REQUEST FOR INFORMATION DATE: September 12, 2016 NO.: RFI-276

Project Name: 15051-Webster University Interdisciplinary Science Building Project No.: 15051

Subject: Guardrail Splice Detail

GUARDRAIL SPLICE DETAIL

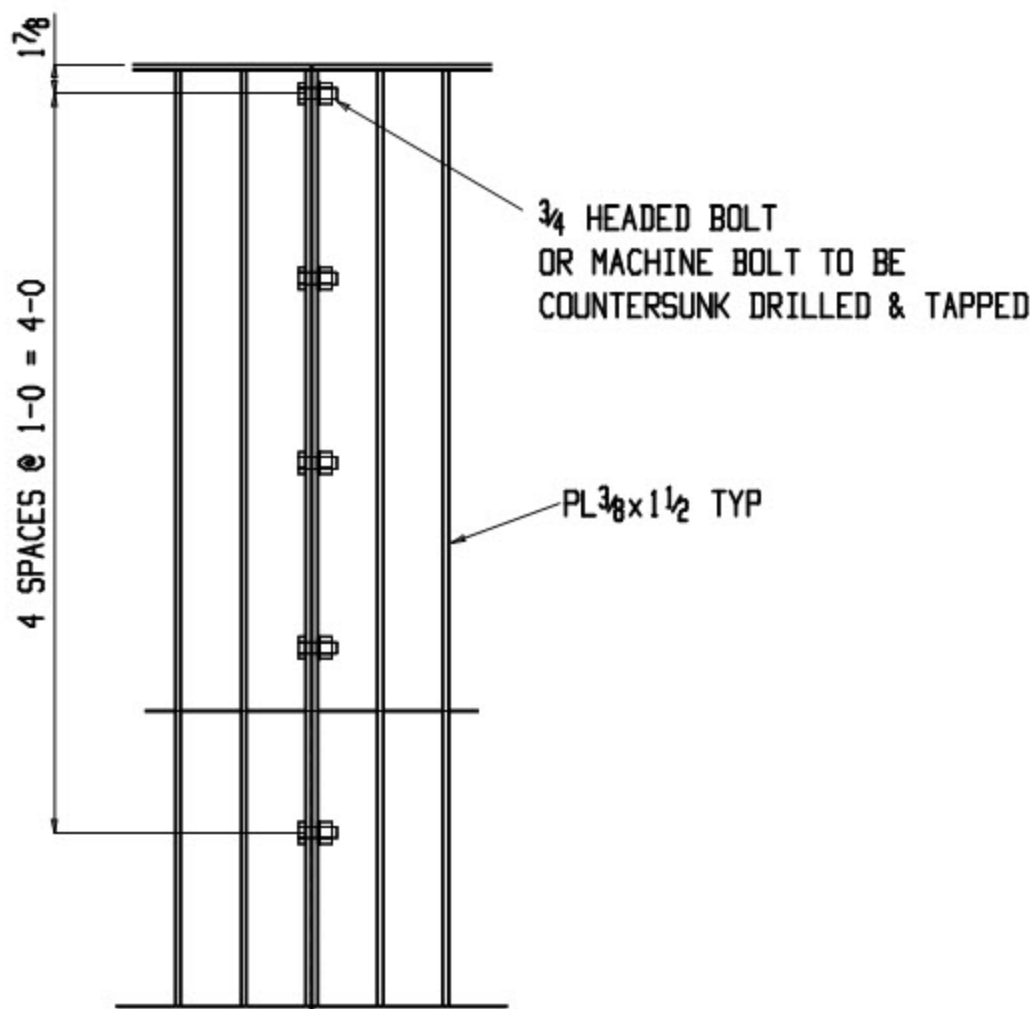
Verify guardrail splice detail acceptable or provide new detail.

This is not acceptable. Exposed bolts are not consistent with the design intent. Provide splice similar to details 3 and 4 on A0508.E (issued with ASI003)
